LiDAR Quality Assessment Report

KS_Area1-Eastern_2013

The project Area 1 Kansas includes Anderson, Allen, Neosho, and Labette counties. Areas were defined and supplied by Kansas Department of Administration and includes approximately 2250 square miles for analysis.

Checkpoint Distribution Image

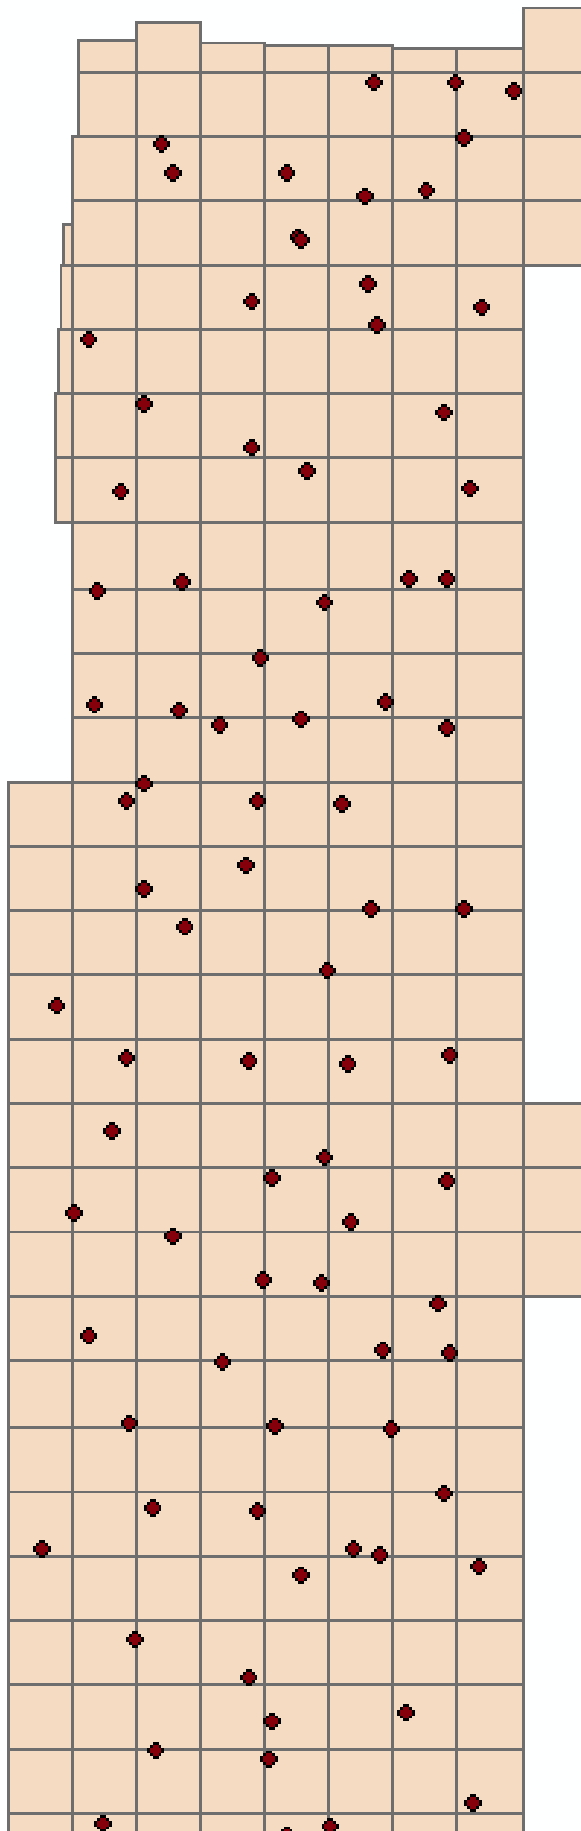
<p><i>Additional Reviewed Vertical Accuracy Information:</i></p>	<p>Reviewer could not assess DEM vertical accuracy at this time. The checkpoints shapefile was delivered in UTM14 only and per liaison " USGS will want to use the UTM 15 data to match the existing tiles surrounding the project and be in the correct zone". DEM review was completed on data using UTM15. Since swath data delivered only in UTM14, reviewer was able to assess vertical accuracy using checkpoints delivered.</p> <p>Check to ensure that all reported vertical accuracies for swath and DEM are consistent across metadata and reports.</p> <p>***Short grass is used for FVA testing. Long Grass is referred to in the Metadata as "Tall Grass."</p>
--	--

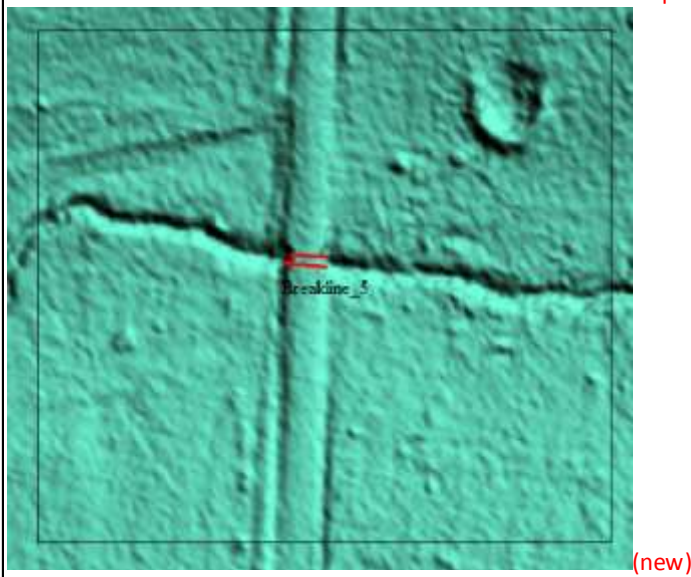
- During QA review, reviewer noted that some rivers in the DEM have been hydro-flattened that appear to be under fifty feet bank to bank, while others have not. Please review/comment. **Corrected by vendor.**
- Breaklines shapefile appears to be incomplete as some hydro-flattened water features are missing breaklines. Re-delivery of breakline file needed. **Corrected by vendor.**
- Some bridges and culverts had breaklines while others did not (as shown below). Please comment. **This problem still exists in some locations.**

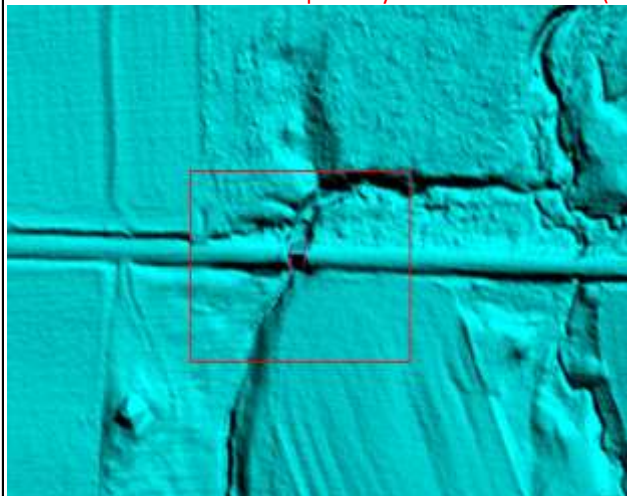
*****some breaklines still exist where culverts have been replaced (image below)

***some breaklines still at partially removed culverts? (image below)

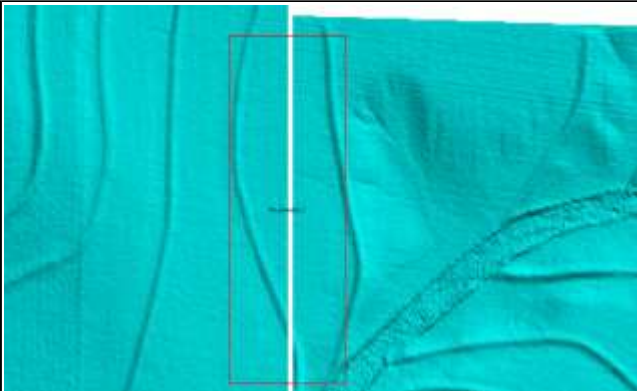
Image from Global Mapper showing tile mismatch (above) and ArcMap (below). **Corrected by vendor.**

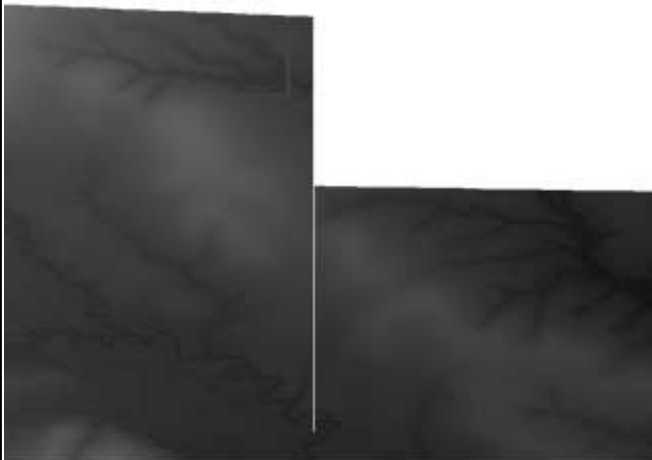
Tile mismatch between DEM tiles BE_15STC8550 and BE_15STC9050. **Corrected by vendor.**

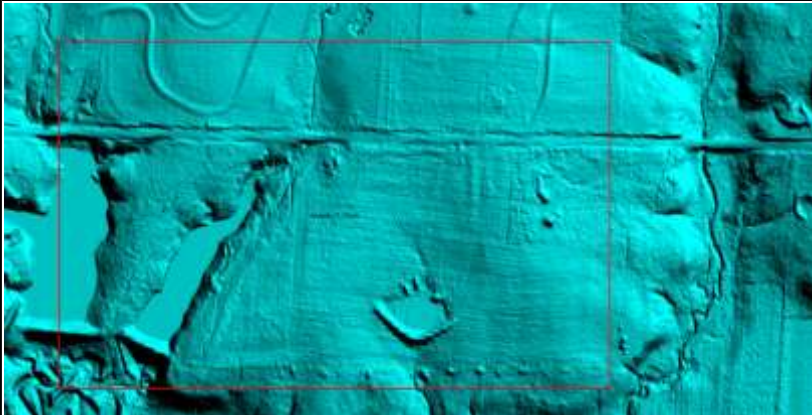
******Boundary shapefile does not conform to data extent (just follows the boundary of the tile extent)**

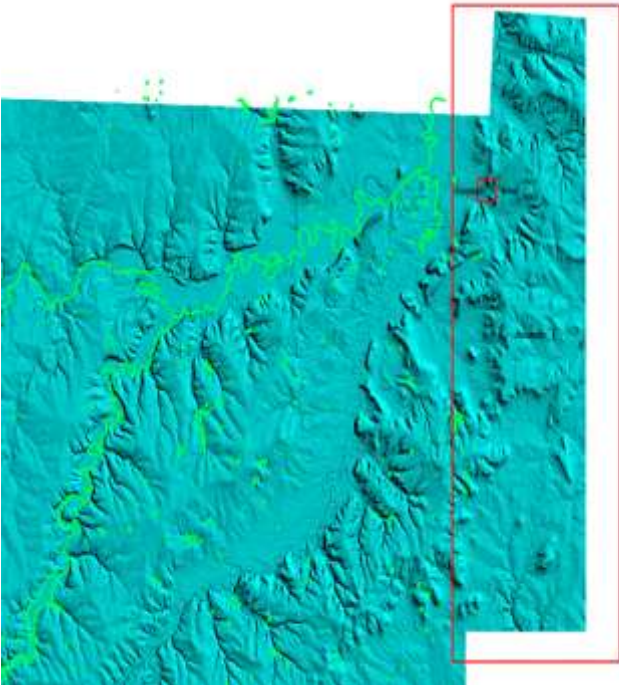
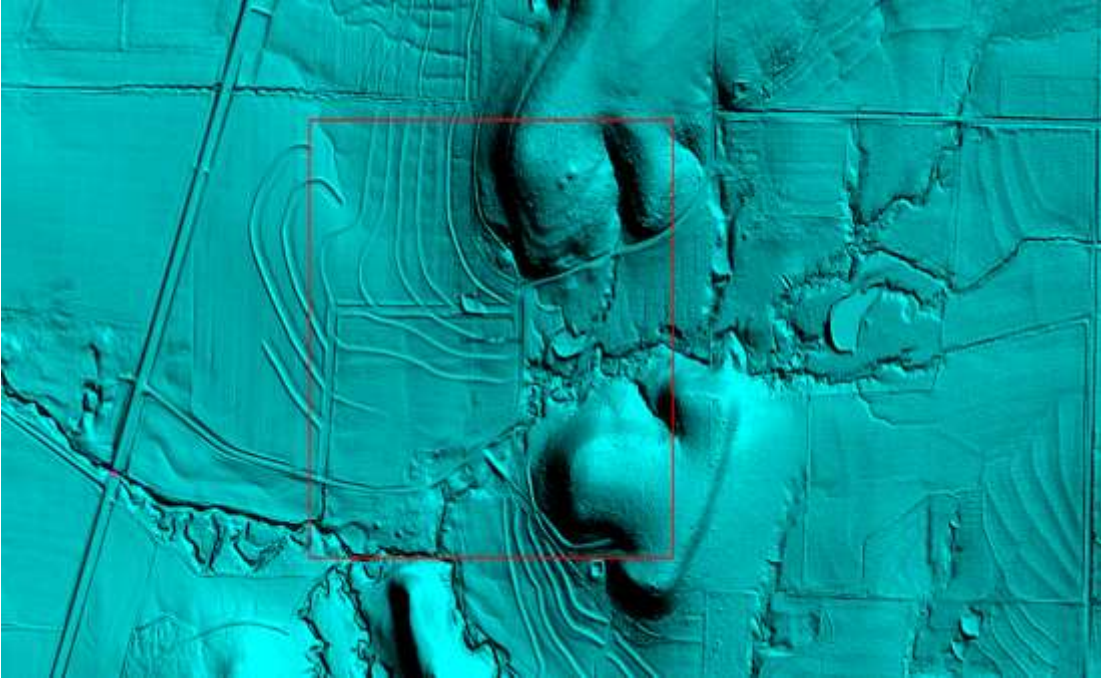
Anomalous error (Anomaly_9) showing different data resolution. Location: 37° 34' 18.9748" N, 95° 06' 11.3445" W
*******Not corrected. Please recheck this.**

*******This errors still exist. It seems to be endemic throughout the north-eastern corner of the dataset. Please recheck (see new error images below and in error shapefile).**

Error identified along entire eastern edge of DEM. Location: 37° 57' 1.2367" N, 95° 07' 50.7476" W *****Not corrected

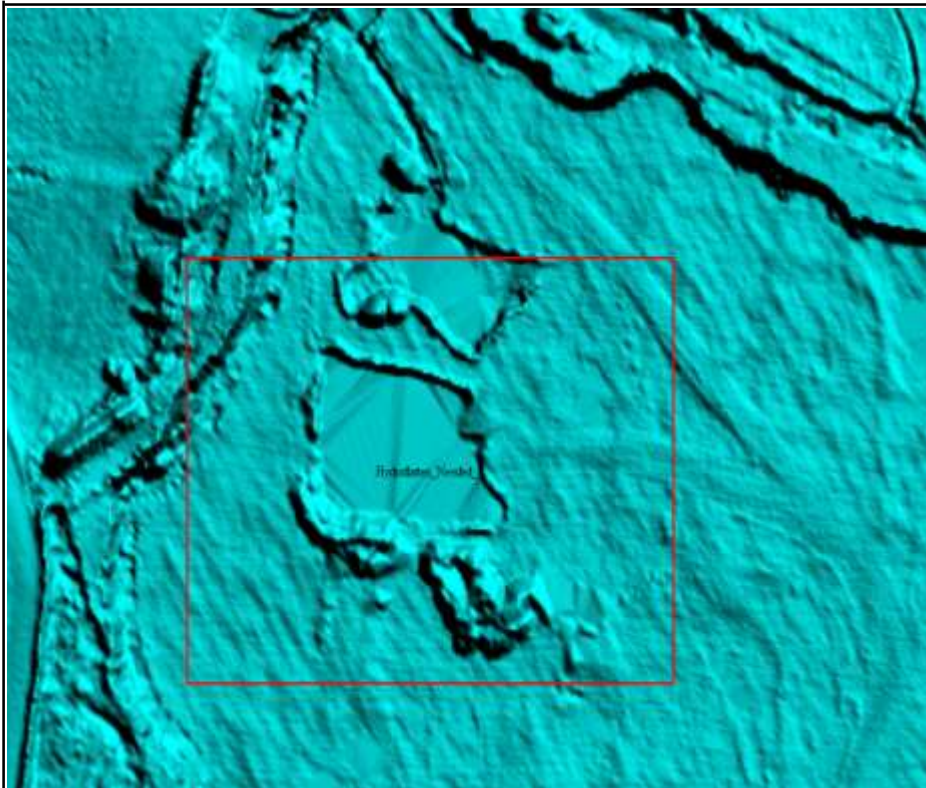
Hydro-flattening error (Hydroflatten_Needed_5). Location: 37° 45' 54.2384" N, 95° 26' 20.3021" W. Three similar errors exist. *****Corrected by vendor

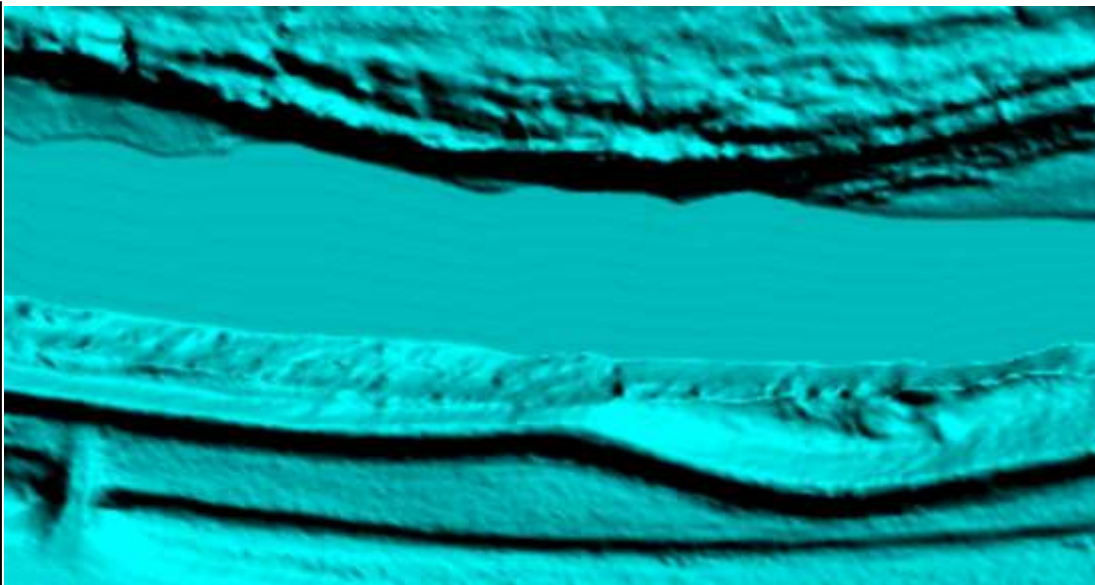
Several hydro-flattening errors exist within the streams. Image above is representative (Water_Issue_11). 15 of these error types exist; please review river system where errors exist.

***River errors corrected by vendor

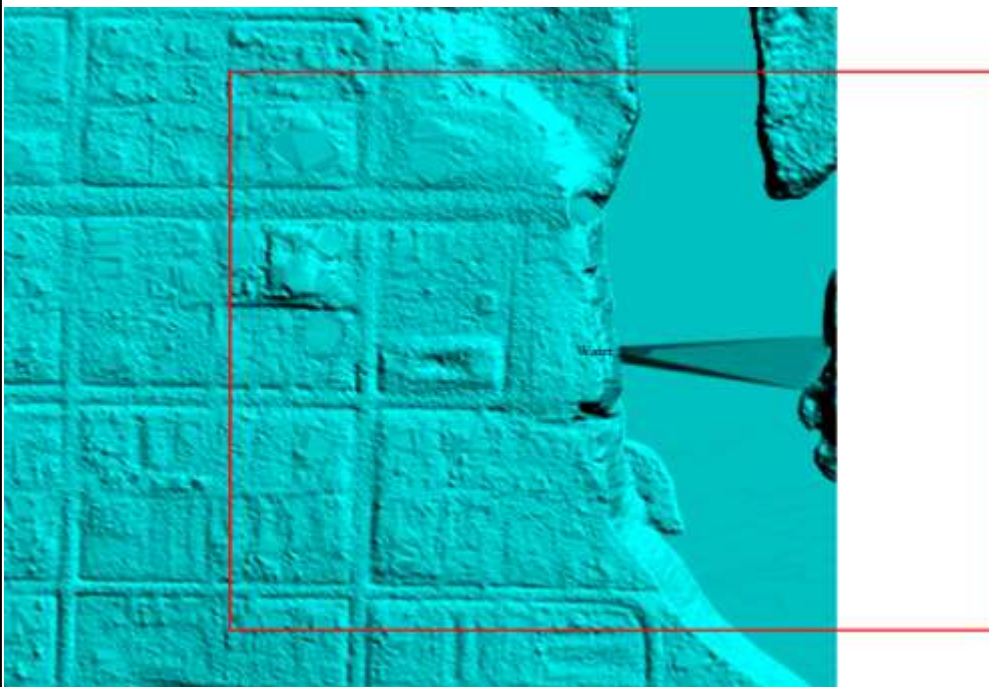
***Water issue beneath bridge.

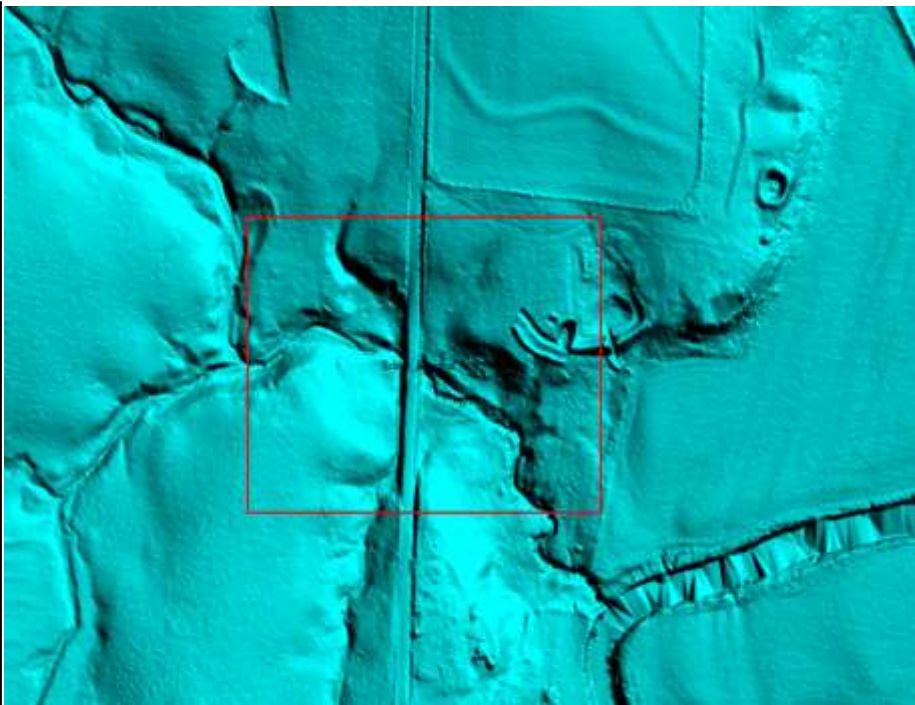
Several errors exist where bridges were not removed from DEM. Above image is representative (Bridge_Removal_6). Location: 37° 34' 39.3071" N, 95° 08' 34.2986" W ***Corrected by vendor

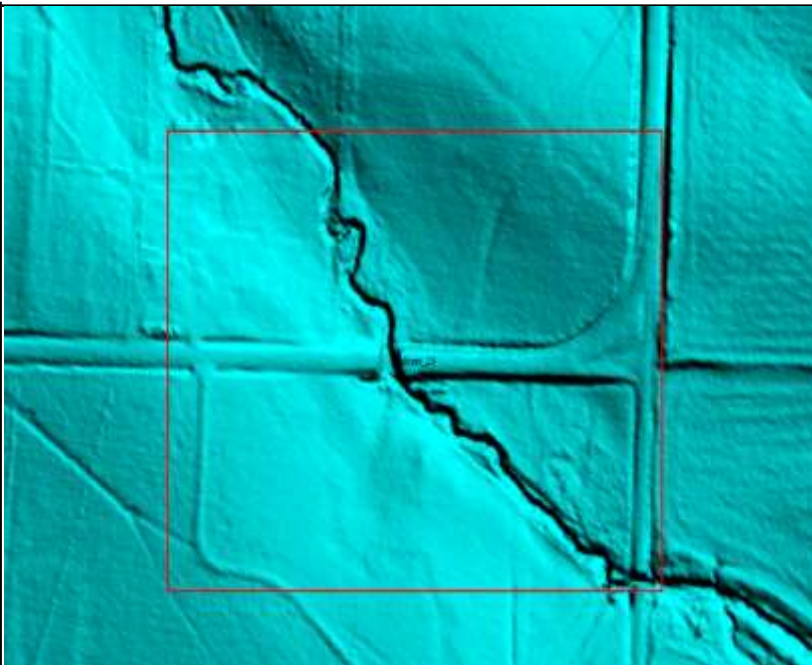
Culvert errors in which culverts were removed from DEM and need to be added back in. Above image is representative (Culvert_29) Location: 37° 52' 41.9722" N, 95° 25' 45.0572" W. 97 of this error type exist. ***Corrected by vendor

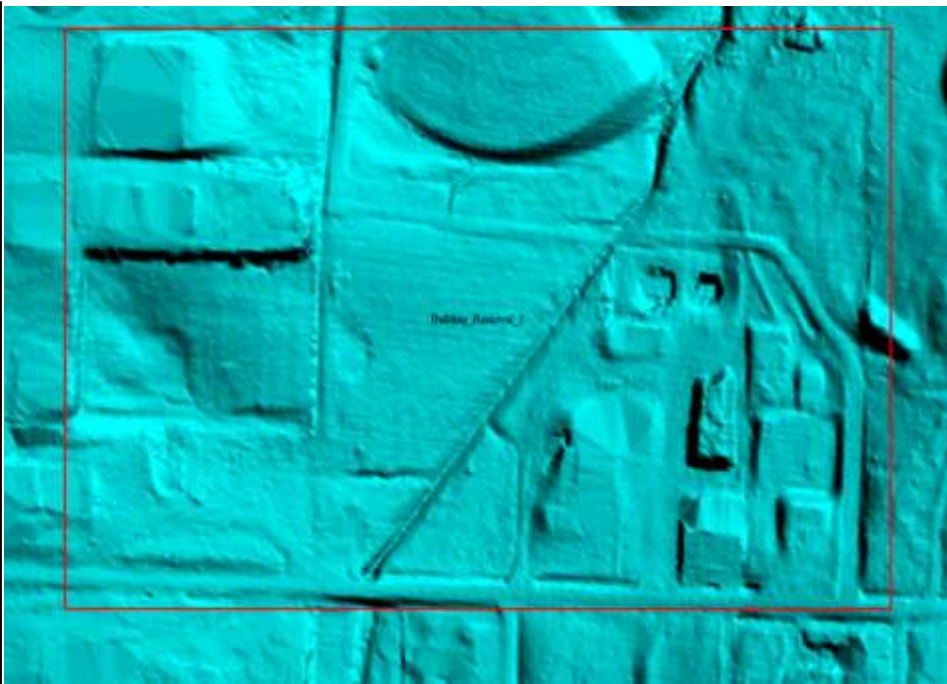
Buildings not removed from DEM. The above image is representative of this error type (Building_Removal_1). Location: 38° 17' 21.8901" N, 95° 14' 43.5772" W. 4 of this error type exist. *****OK, thanks for info.**
